**DEVIATION REQUEST
AND DECISION FORM**

Project Name : Yucatan Convenience Store
 Schedule No.(s) : 6501205016
 Legal Description : Lot 1 Clearview West Filing No. 2 (4815 Yucatan Dr. Colorado Springs, CO 80911)

PCD # DEV-22-4

Urban Minor Arterial Roadway, Standard Cross-section:
El Paso County Engineering Criteria Manual – Appendix F, Standard Drawing SD_2-5

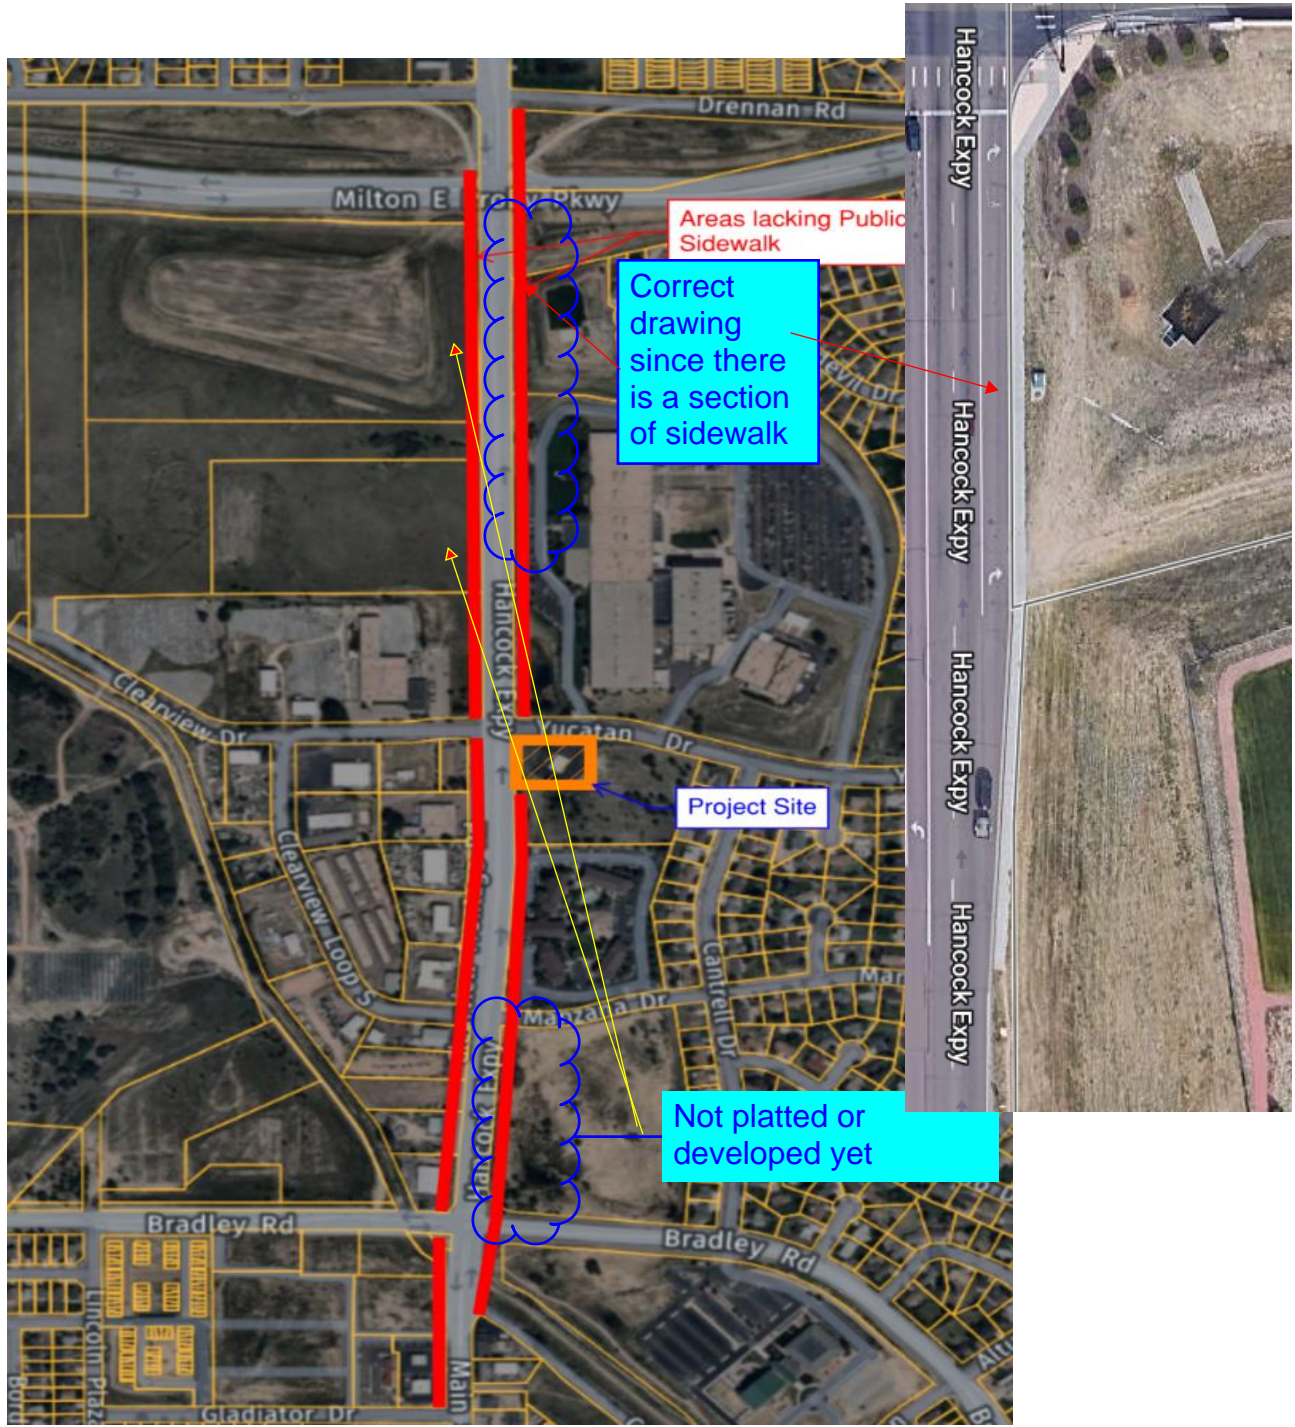
A deviation to the typical Minor Arterial cross-section by not installing a North/South bearing sidewalk along the eastern edge Hancock Expressway is requested for the following reasons:

1. There is no sidewalk on the eastern edge of Hancock Expressway to the North or South to tie into, despite these properties having been previously developed. These developments do not provide any pedestrian access to tie-in to. Additionally, there is no sidewalk along the eastern edge of Hancock Expressway until near the intersection with Milton E Proby Parkway.
2. There is no sidewalk on west edge of Hancock Expressway until north of Milton E Proby Pkwy.
3. There is no sidewalk along either side of Clearview Frontage Road, west of Hancock Expressway across from development.

All businesses in the vicinity and along Hancock Expressway are set-up for Vehicular Access, discouraging pedestrian accessibility. The requirement for providing a North/South bearing sidewalk is inconsistent with the surrounding developments as there is nothing for pedestrians to utilize in the area, and no accessways for them to use for access for these improvements.

The proposed alternative is not to install a sidewalk along the western edge of the site, instead leaving existing vegetation and landscaped area undisturbed. Because the proposed development will not increase pedestrian traffic, the existing pedestrian facilities (a single sidewalk along Yucatan Drive at the north end of the site) will be sufficient to handle the limited amount of pedestrian traffic expected.

Not recommended for approval

Please sign and stamp and resubmit for final response
